DN-46.1*

TECHNICAL BULLETIN

SUBJECT: FIELD MODIFICATION OF PN 369D21002 SCISSORS CRANK ASSEMBLY, MAIN ROTOR HUB - UPGRADE TO PN 369D21002-21 CONFIGURATION

MODELS AFFECTED: 500D Model 369D Helicopter Serial No. 0003D thru 0209D

Figure 2. Installation of 369D21002-21 Crank to Hub Lower Shoes

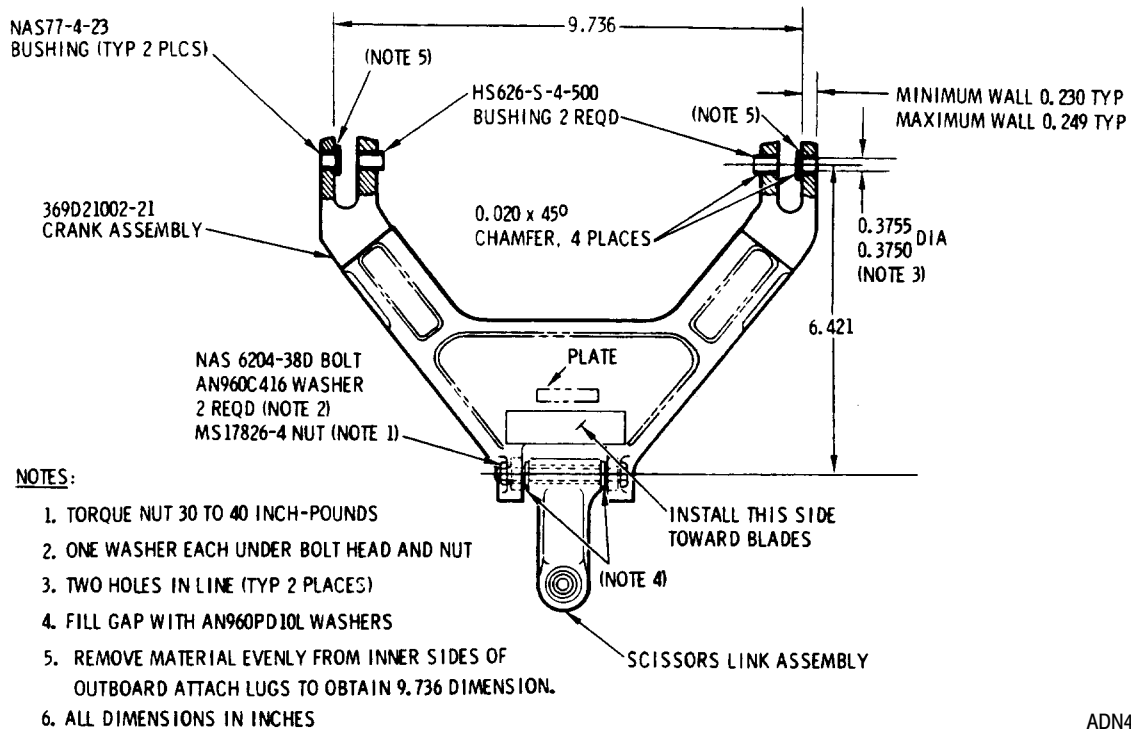
- g. Reidentify crank assembly as PN 369D21002-21 on ID plate.
- h. Reinstall scissors crank assembly using new attach hardware as follows:
 - 1. Install scissors crank to hub lower shoe with NAS6204-18D bolts, AN960PD416L washers, MS178 26-4 nuts and cotter pins as shown in Figure 2. Torque nuts to 30 to 60 inch-pounds.

Figure 1. Field Modification - 369D21002-11 Crank Assembly to 369D21002-21 Configuration

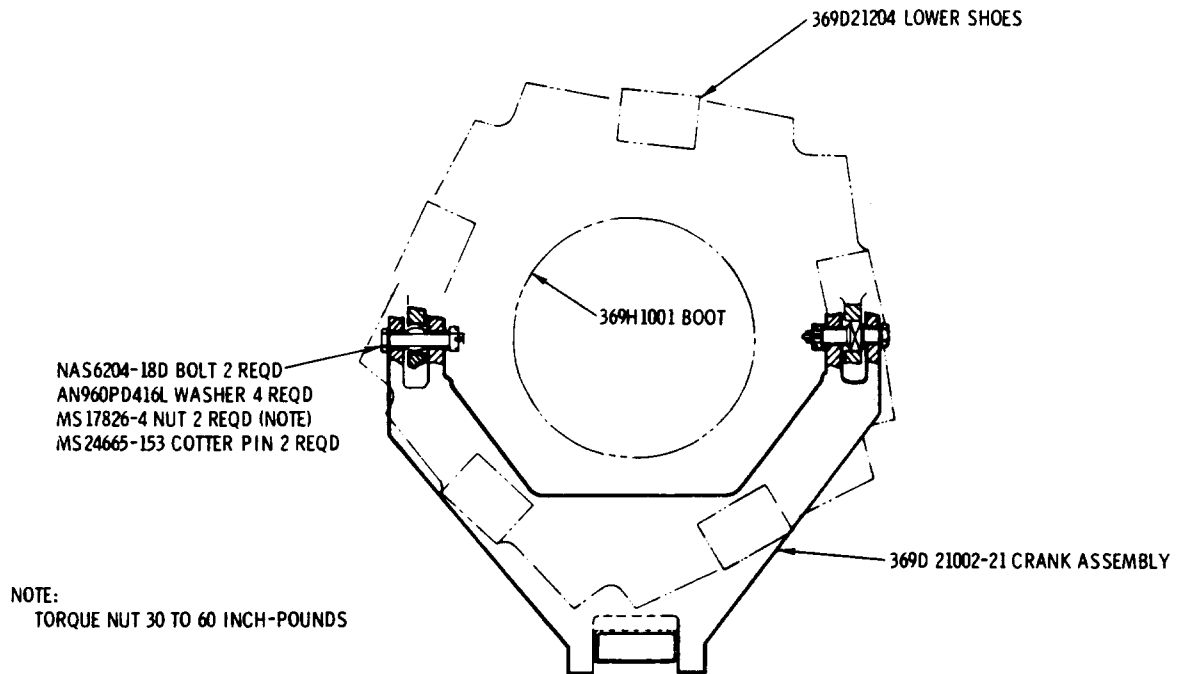
PREFACE: The information given in this Service Information Notice lists a procedure for modification of the subject PN 369D21002 main rotor hub scissors crank assembly to the current PN 369D21002-21 configuration, to preclude shimming problems experienced with the early crank configuration. Field rework consists primarily of relocating existing bushings in the crank outboard attach lugs to the inboard lugs, and installing new flanged type bushings in the outboard lugs. The wall thickness of the crank outboard attach lugs must be reduced to accommodate installation of the flanged bushings.

- a. Disconnect scissors crank from hub lower shoe and scissors link. (Refer to Basic HMI-Vol I)
- b. Remove existing HS626-S-4-500 bushings from outboard lugs of scissors crank. (See Figure 1.)
- c. Using grinder or file, remove minimum 0.063 inch material from inner side of both outboard attach lugs, to obtain distance of 9.736 inches between lugs (See Figure 1). After removal of material, wall thickness of lug should not be less than 0.230 inch. Coat reworked area of lugs with iridite or equivalent corrosion protection chemical film.

Remove material from inner side only of existing crank outboard attach lugs.

- d. Using existing hole in outboard lugs as guide, drill and ream 0.252 inch diameter hole in inboard lugs to 0.3750 - 0.3755 inch diameter for press fit of HS626-S-4-500 bushings.

- e. Install HS626-S-4-500 bushings in inboard lugs of scissors crank with zinc chromate primer.
- f. Install new NAS77-4-23 flanged bushings with zinc chromate primer in outboard lugs as shown.

- a. Install scissors link to scissors crank assembly with NAS6204-38D bolt, AN960C416 washers, MS178 26-4 nut and cotter pins, as shown in Figure 1. Torque nut to 30 to 40 inch-pounds.
